PLANNING COMMISSION
Regular Meeting
Monday, February 11, 2019
6:00 PM
Christine Nuernberg Hall

Agenda

TO: Planning Commission
FROM: PA PHOUALA VANG, PLANNER
DATE: February 11, 2019
SUBJECT: First Weber for Catherine & James Hurth. The applicant is seeking certified survey map approval for a 2-lot land division for the property located at 12501 N. Lake Shore Drive and parcels to the west and north.

TO: Planning Commission
FROM: JAC ZADER, ASSISTANT DIRECTOR COMMUNITY DEVELOPMENT
DATE: February 11, 2019
SUBJECT: ICAP Development for Jewish Home and Care Center, Inc. The applicant is seeking rezoning recommendation approval from IPS (Institutional and Public Service) to B-2/PUD (Commercial Business/Planned Unit Development) for the property located at 10865-10911 N. Port Washington Road.

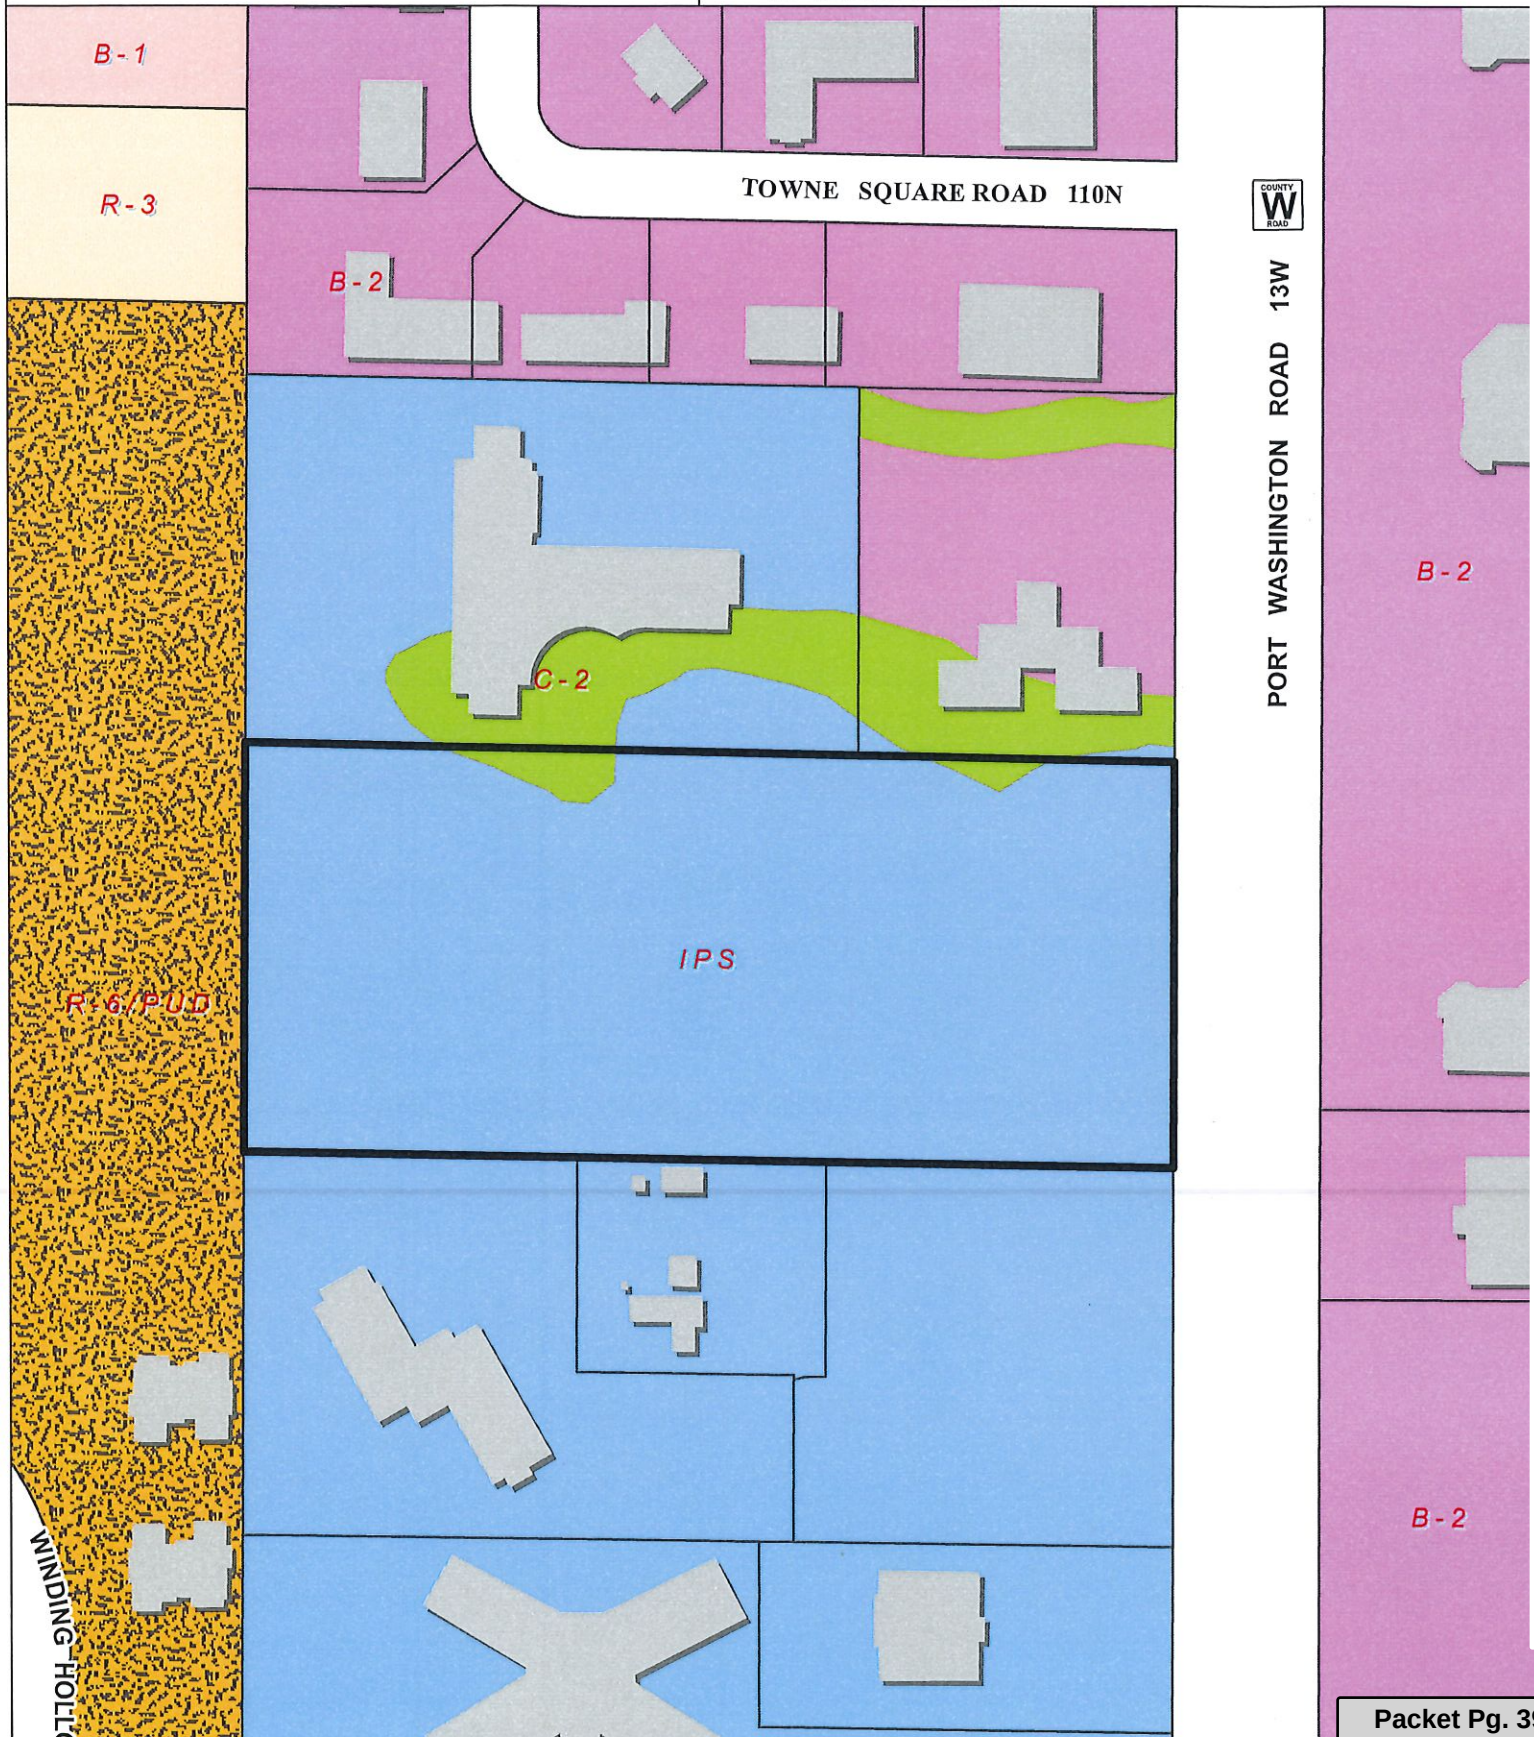
The concept plan shows a total of five buildings located on the site with 291 total parking spaces and four storm water detention facilities. There are three separate access shown points to Port Washington Road which is under the jurisdiction of Ozaukee County. Based on correspondence with the county, preliminary approval has been conditionally approved based on the results of a pending traffic study. The plan does not state whether it complies with FAR or greenspace requirements. Based on the overall parcel size, staff does not recommend any deviation from the code requirements. As a condition of approval, staff will require that the entire development comply with open space and FAR requirements.

Overall, staff feels the concept plan does a nice job in master planning the site with shared parking, access and detention facilities. Staff does have an issue with the proposed orientation of the buildings along Port Washington Road. As with the Associated Bank project, staff will require as a condition of approval that all buildings shall be orientated towards Port Washington Road and any proposed drive thru shall be to the rear of the building. This may require a modification to the proposed land division boundaries.

Based on the restriction being placed on the site, staff is supportive of the base district zoning change to the B-2. While the concept plan does a nice job in coordinating shared access and incorporating shared facilities like parking and storm water, the impact of the specimen trees and the orientation of the buildings will require substantial modifications to the plan. Because of this, staff is recommending the item be tabled until these issues can be vetted out. The applicant is aware of the issues and will be looking at revisions to the concept plan; however they would like feedback from the Commission regarding the rezoning to B-2 prior to tabling the item.

Planning staff recommends tabling the rezoning request and concept plan.
